**STATE OF TENNESSEE
DEPARTMENT OF TRANSPORTATION**

INSTRUCTIONAL BULLETIN NO. 17-09

Regarding Revised Standard Drawings

Effective February 9th, 2018 letting (November 29th, 2017 Turn-in), the following Standard Drawings have been revised. Also, Section 5, Index of Standard Drawings, of the Roadway Design Guidelines has been revised to incorporate these changes.

EC-STR-11

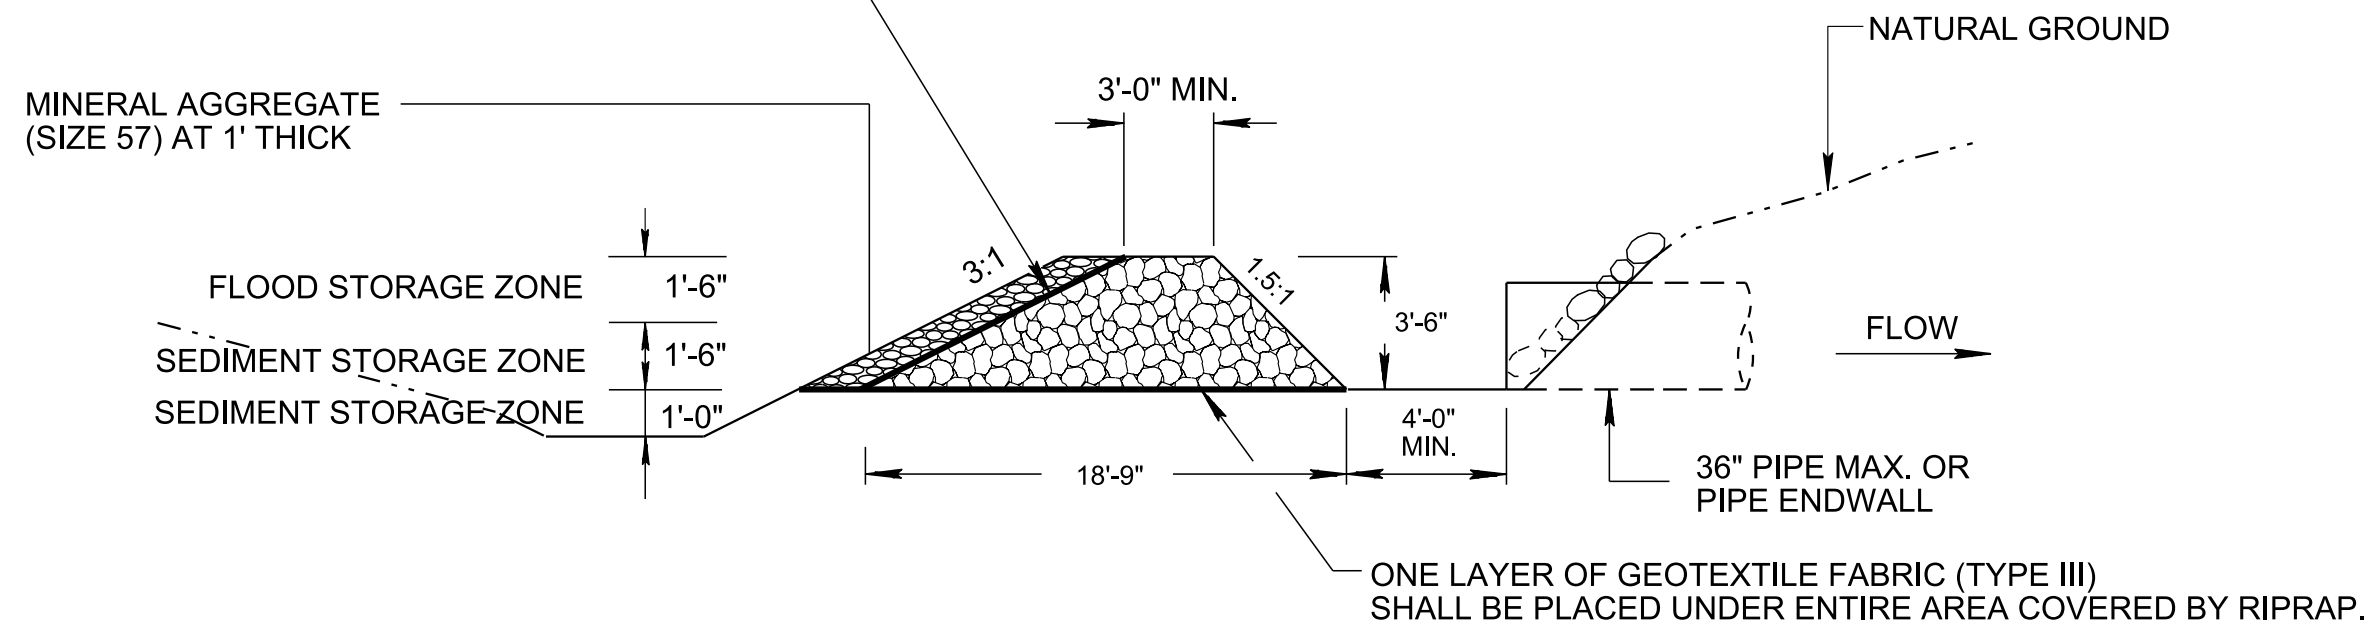
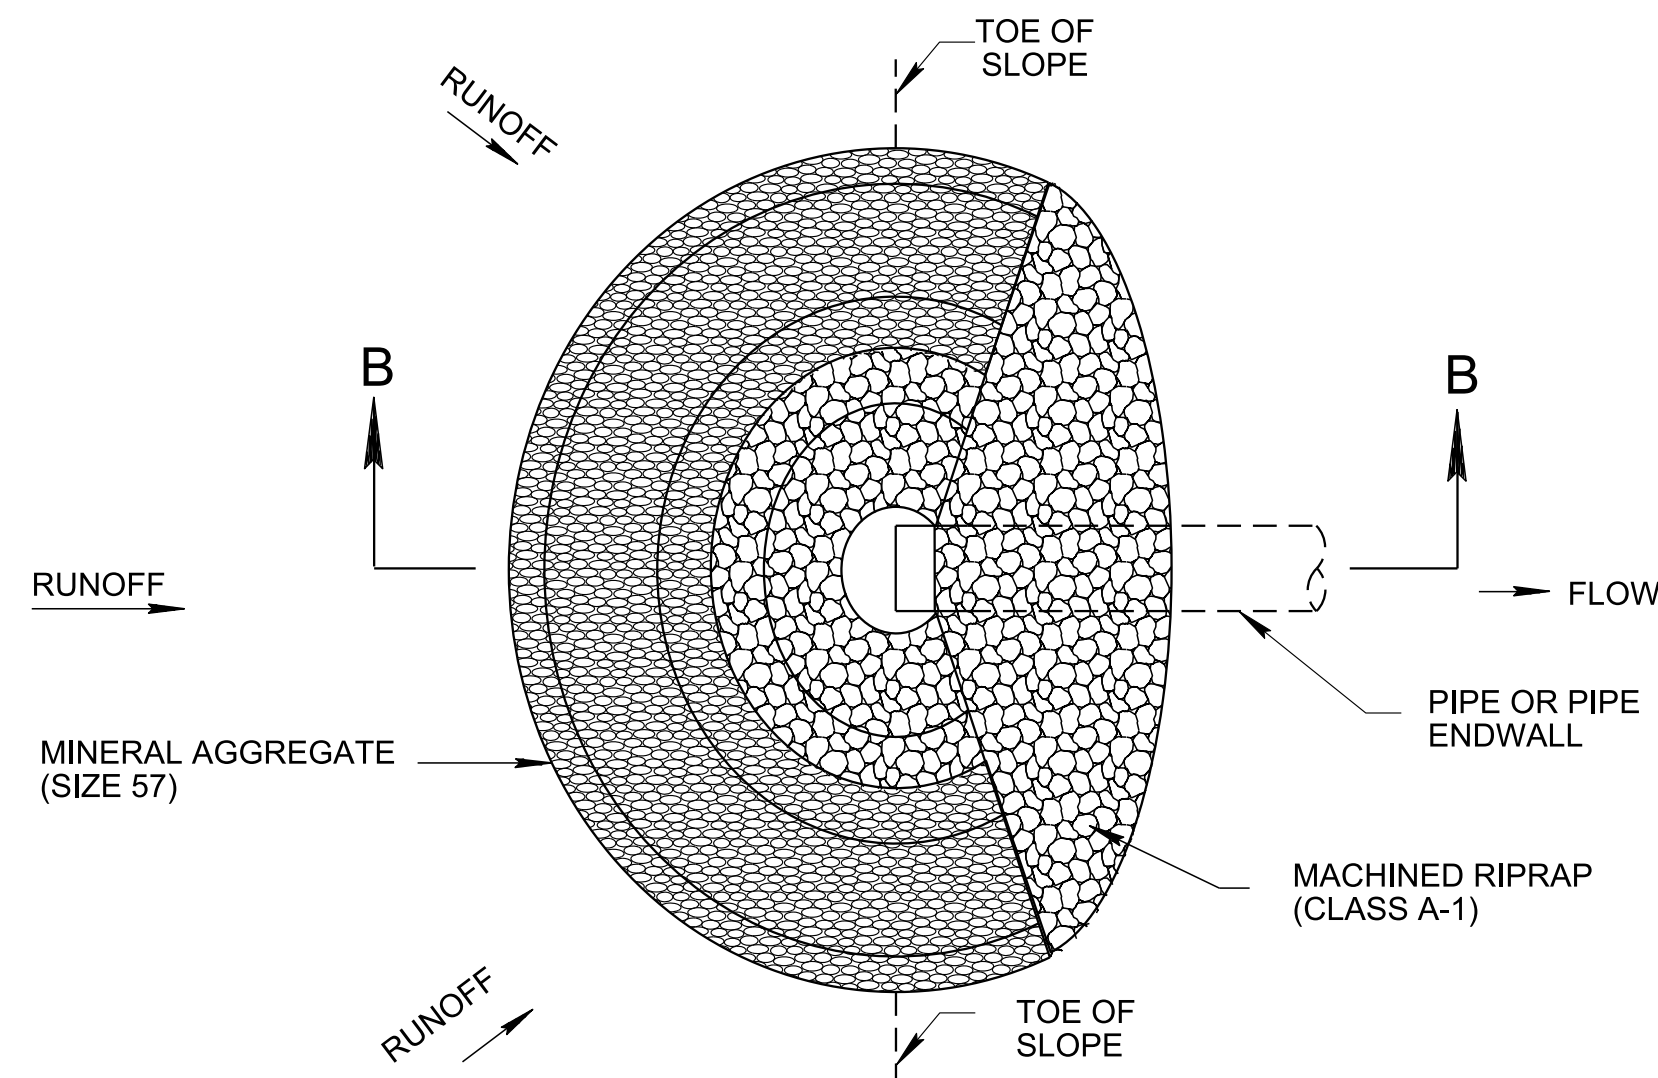
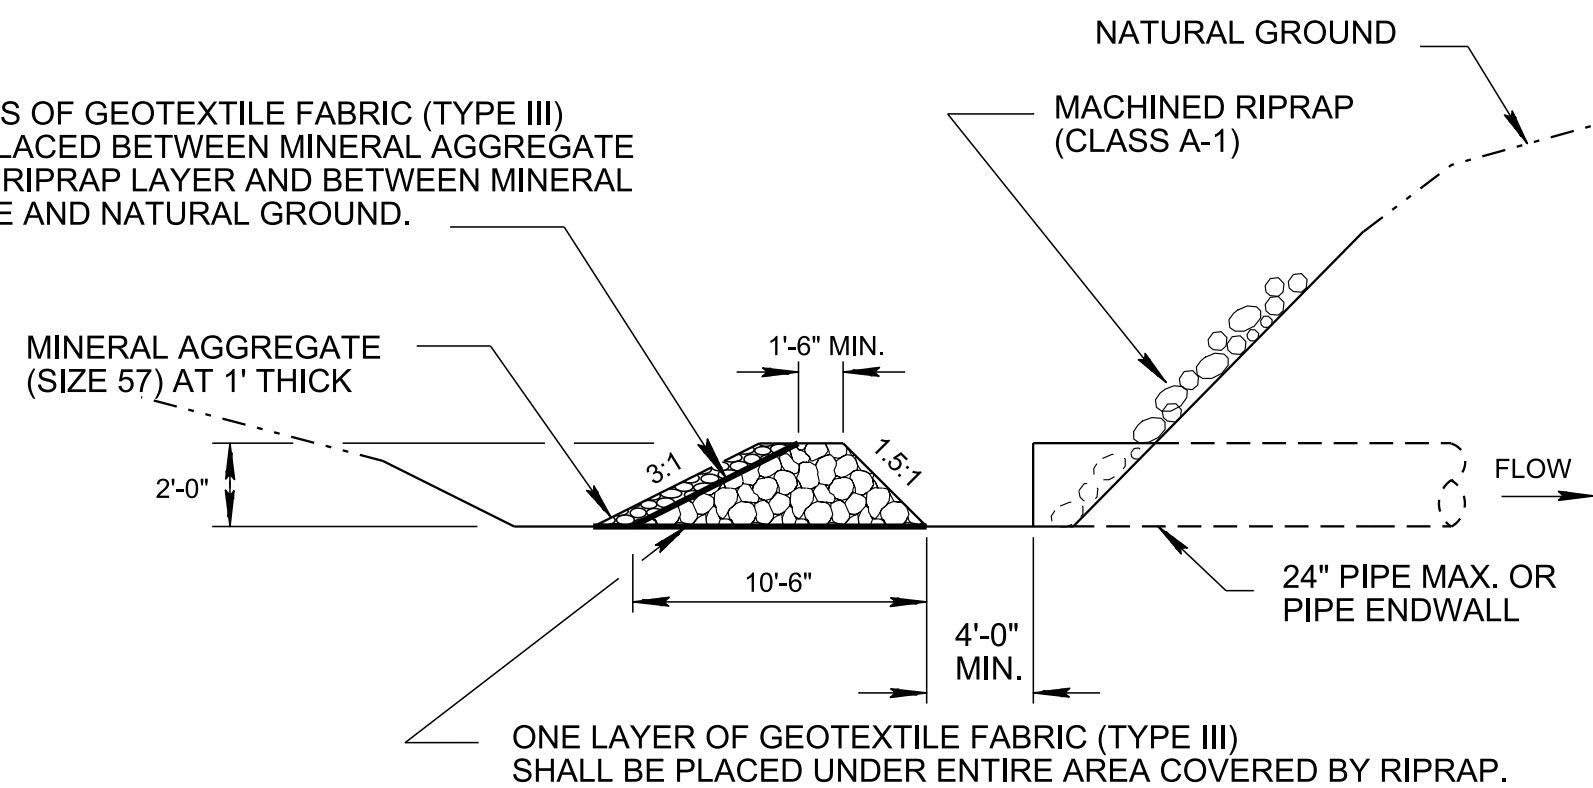
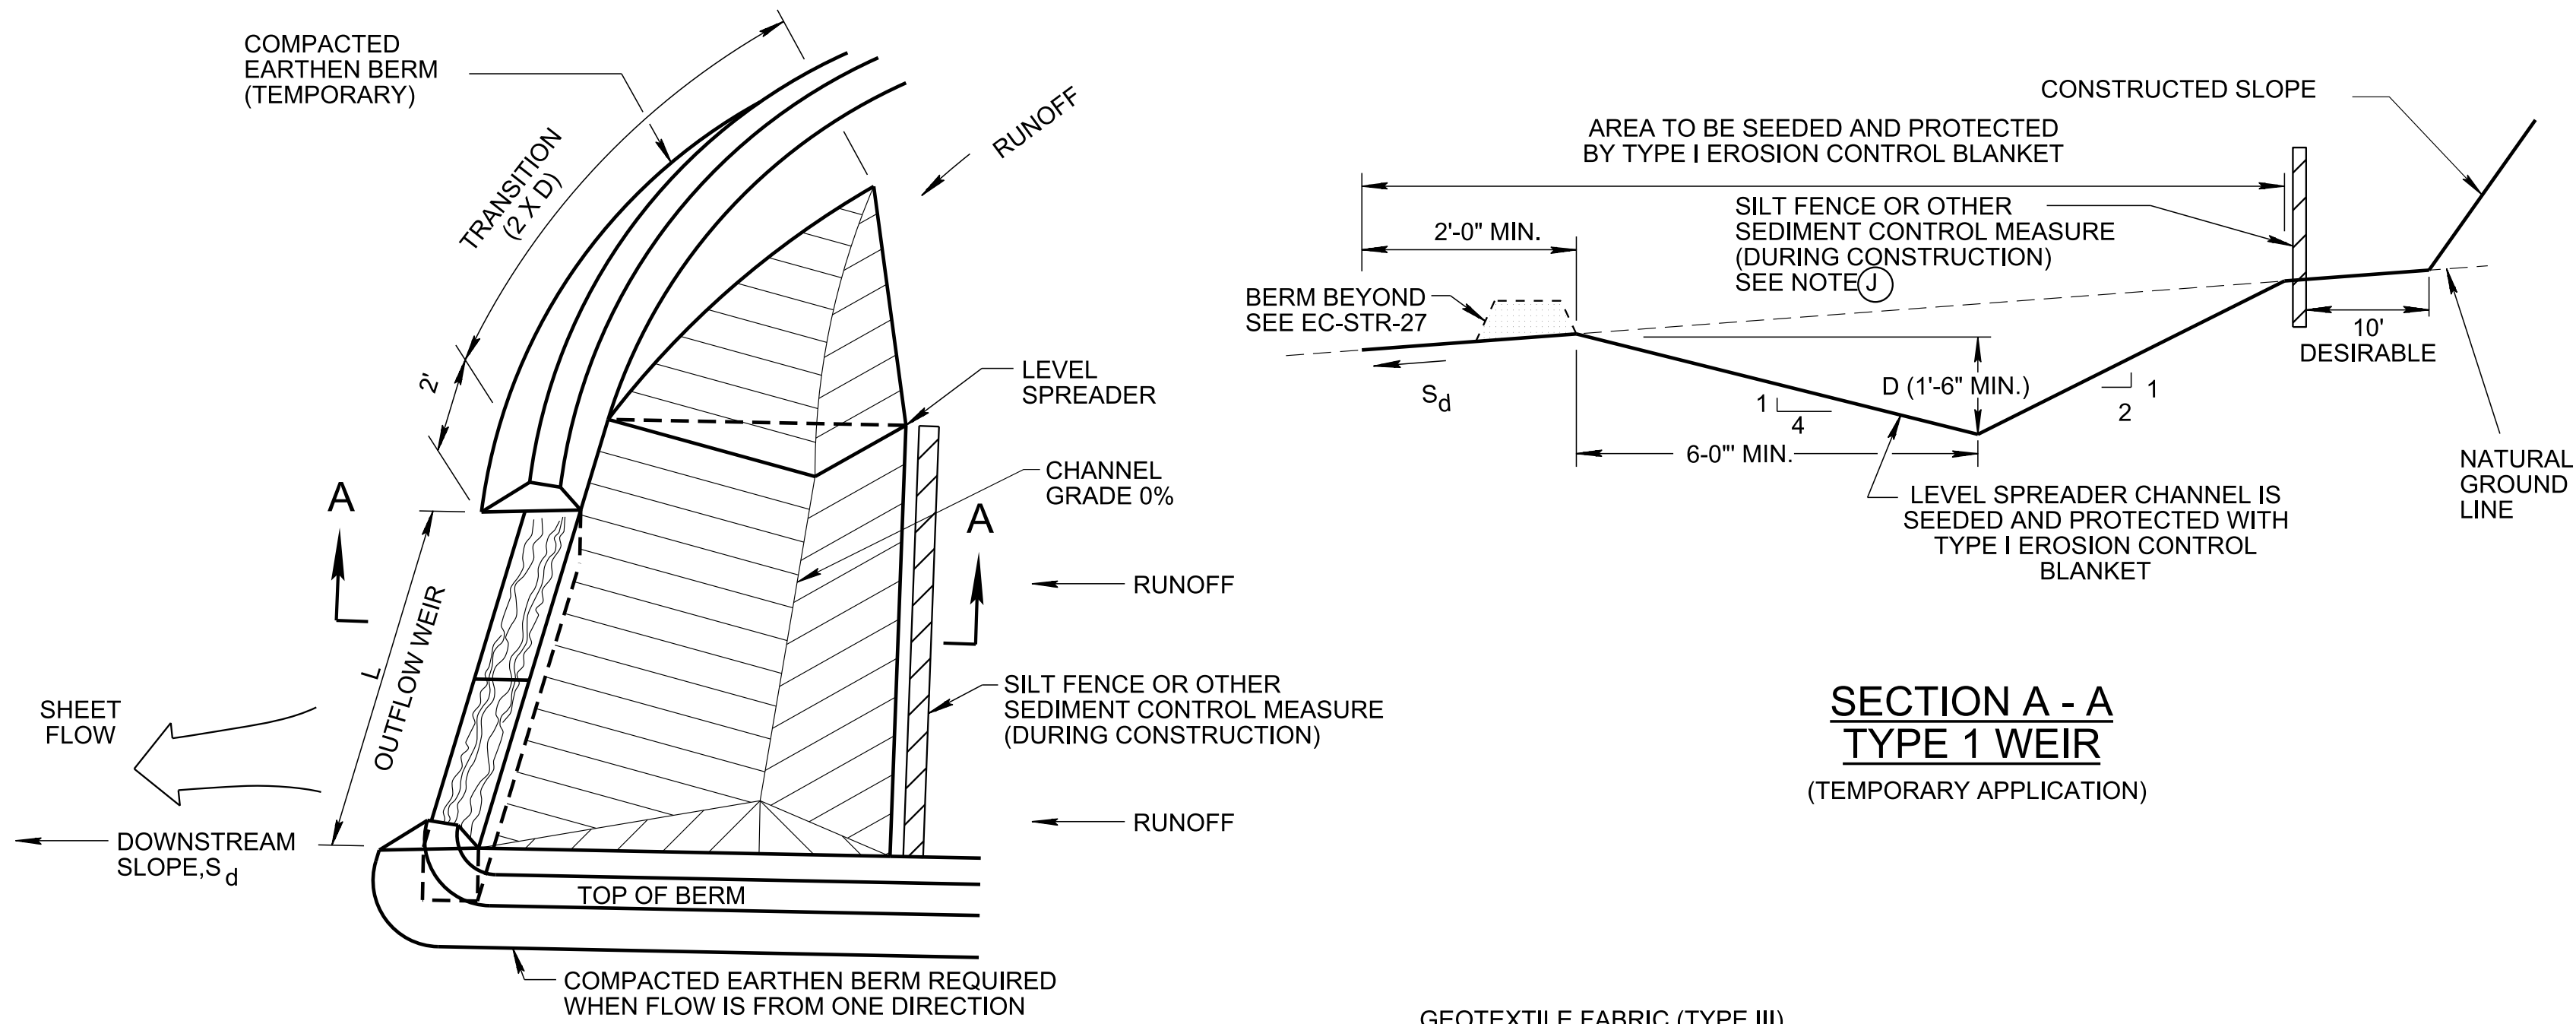
- REV. 3-16-17: CORRECTED PAY ITEM NO. 209-05.
